ENSTROM HELICOPTER CORPORATION

SERVICE DIRECTIVE BULLETIN NO. 0106

1. SUBJECT: Main Rotor Pitch Change Bellcranks Missing Chamfers
2. MODEL: F-28A, F-28C, F-28F, 280, 280C, 280F, and 280FX
3. EFFECTIVITY: All serial numbers
4. BACKGROUND:

Figure 1. Chamfer on the inboard ear – two places

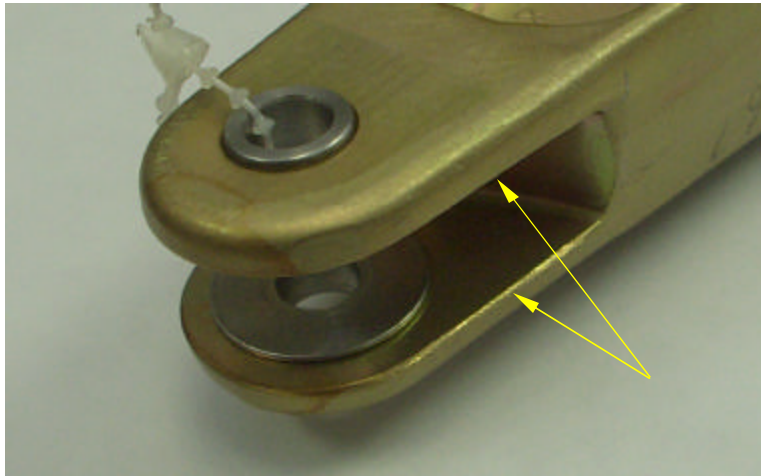
- A. Using a suitable light source and inspection mirror or by disconnecting the pitch change bellcranks from the main rotor control rods and attachment bracket, inspect the bottom of the inboard ears for a .02" - .04" X 45° / 0.5 mm – 1.0 mm X 45° chamfer (refer to Figure 1). If chamfers are not on the Bellcrank(s), rework the Bellcrank(s) to add the chamfers IAW paragraph 5.2. If the chamfers are on the Bellcranks, reinstall the Bellcranks and return the aircraft to service.

Figure 2. Dimensional data for chamfer application

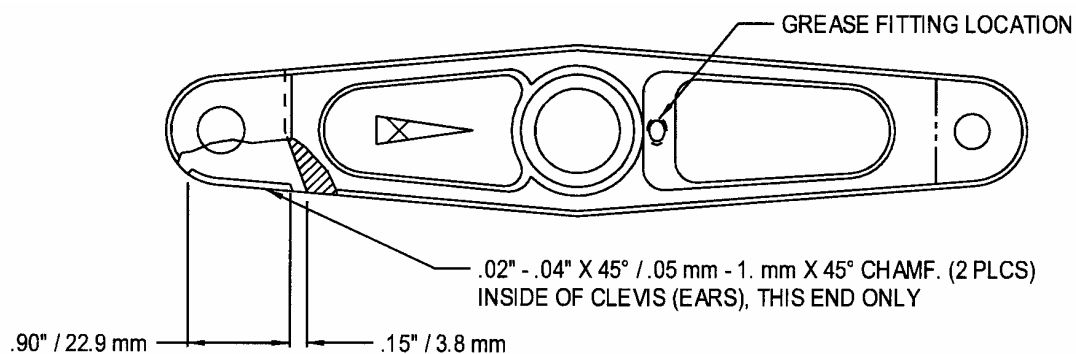
- A. Remove the Pitch Change Bellcranks from the helicopter following the procedures in the applicable maintenance manual.
- B. Using a small file or other suitable device, add a .02" - .04" X 45° / 0.5 mm – 1.0 mm X 45° chamfer to both sides of the bottom inboard ear (refer to Figure 2). Apply a protective coating of epoxy primer (Desoto #593 X 300 or equivalent) to the reworked area.
- C. Reinstall the Pitch Change Bellcranks following the procedures in the applicable maintenance manual and return the aircraft to service.

NOTE: BLEND ENDS OF CHAMFER INTO ADJACENT MATERIAL
